Warren County Regional Planning Commission

This letter is in regard to the SR 741 & Red Lion Five Points Road (Oberer) PUD Stage 1, in Clearcreek Township.

MEETING DATE: November 15, 2018
TO: WCRPC Executive Committee
FROM: Zachary Moore, Senior Planner
SUBJECT: SR 741 & Red Lion-Five Points Rd
 (Oberer) PUD Stage 1

EXHIBIT A - Revised P.U.D. [Concept] Plan (received by RPC 11/6/18)

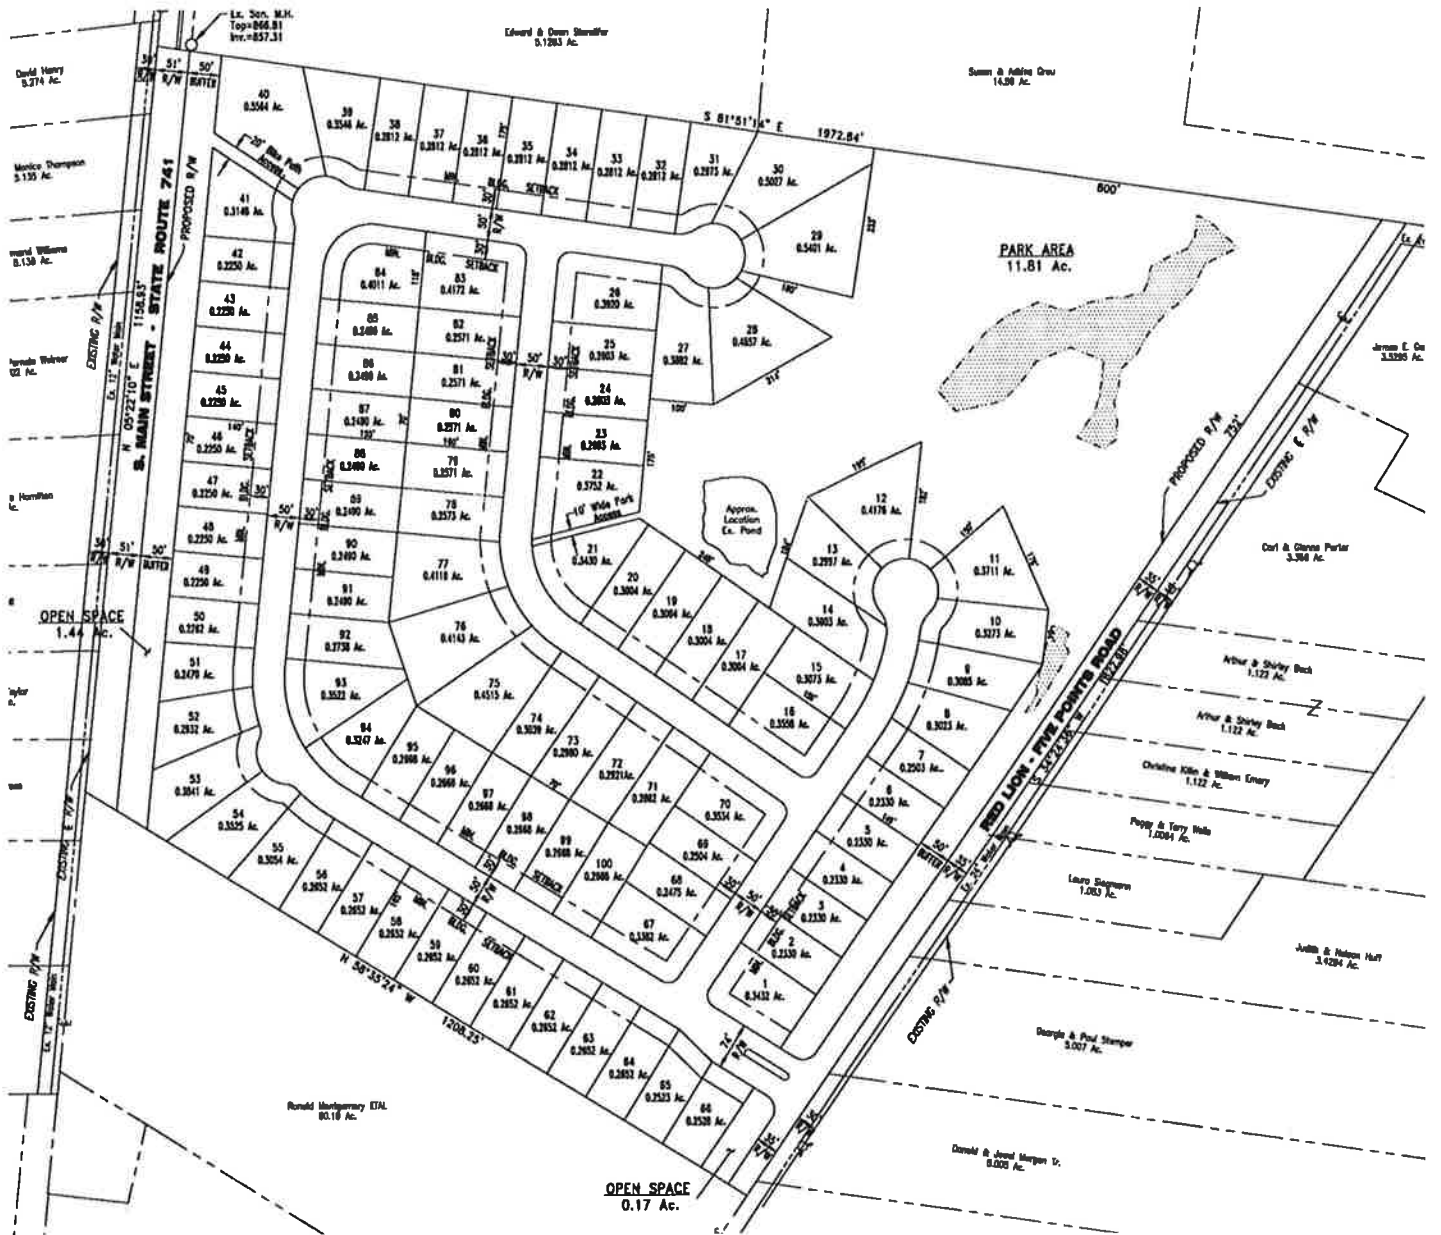
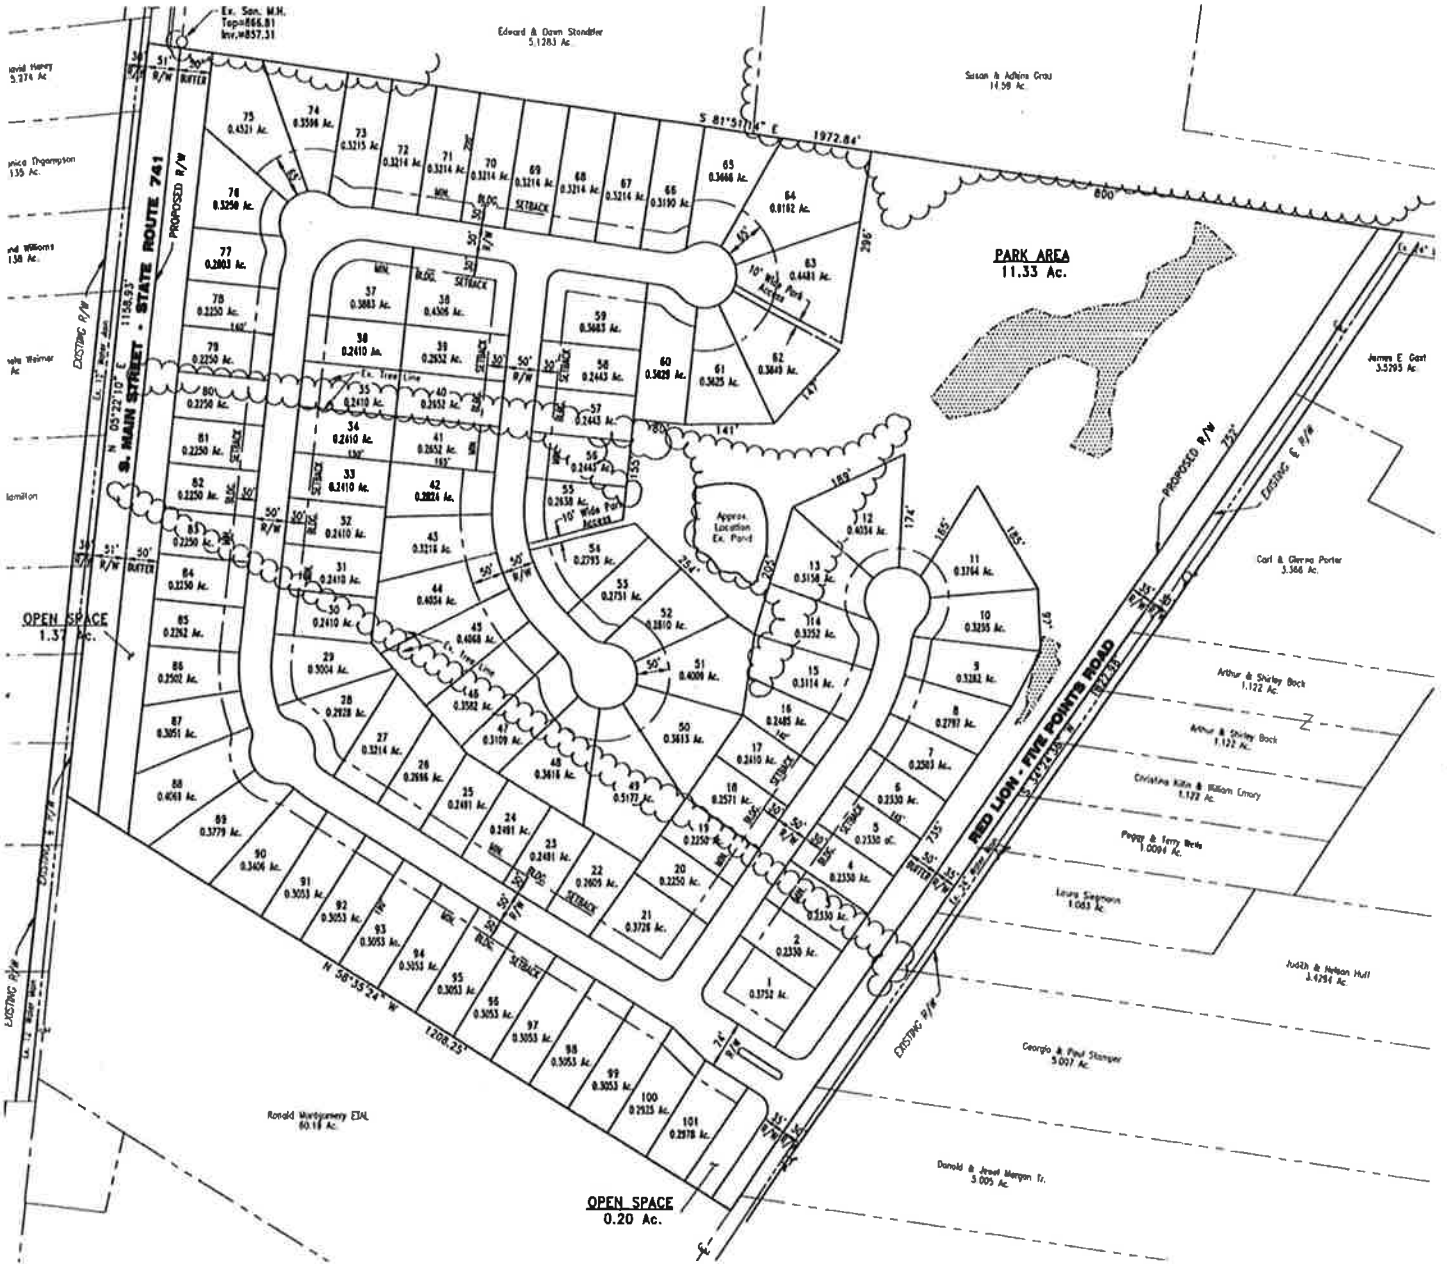
An entrance is not currently shown from SR 741, however staff believes an additional second entrance is warranted due to the number of units proposed. Providing a second entrance would likely help alleviate any potential congestion at the intersection between SR 741 and Red Lion-Five Points Road further south, and help facilitate easier access to nearby destinations in Springboro, such as the high school campus.

Streets within the subdivision are planned to be curb & gutter, and will follow the Warren County Engineer's standard cross-section comprising 50 feet of right-of-way width. A stub street is recommended to be required to the southern adjacent parcel (see Section 7.4), unless the parcel is placed into a conservation easement or reputable conservation land trust.

The northwestern corner of the P.U.D. Plan shows a 20-foot wide opening leading from a proposed "knuckle" street to SR 741. The intention is to create a connection to the bike lane that currently exists along the eastern side of SR 741 in the City of Springboro. This would provide future residents with bicycle access to destinations within the City of Springboro, including the high school campus.

A minimum of 20% open space is recommended as a standard in Exhibit D, though the developer's plan shows approximately 26% (13.38 acres). A list of acceptable uses within the open space is provided in Section 6.5, with trails as a required amenity. Two wetland areas, totaling approximately 43,200 & 3,100 SF, are shown on the Concept Plan and would be required to remain within the open space area in future plans.

A stub street shall be provided at the time of final plat to the southern adjacent parcel (Parcel ID 08-11-100-070), unless documentation can be provided which proves the parcel has been placed into a perpetual agricultural and/or conservation easement, or is placed into a conservation land trust with a recognized conservation organization found acceptable by the Township. No other street stub connections are mandatory for this PUD, though additional stubs may be provided if desired.

As shown on the Concept Plan, a bike path connection shall be installed in order to facilitate access to the existing bike lane leading north on SR 741 into the City of Springboro. This connection shall be in place no later than the platting of seventy five (75) percent of the lots within the subdivision.
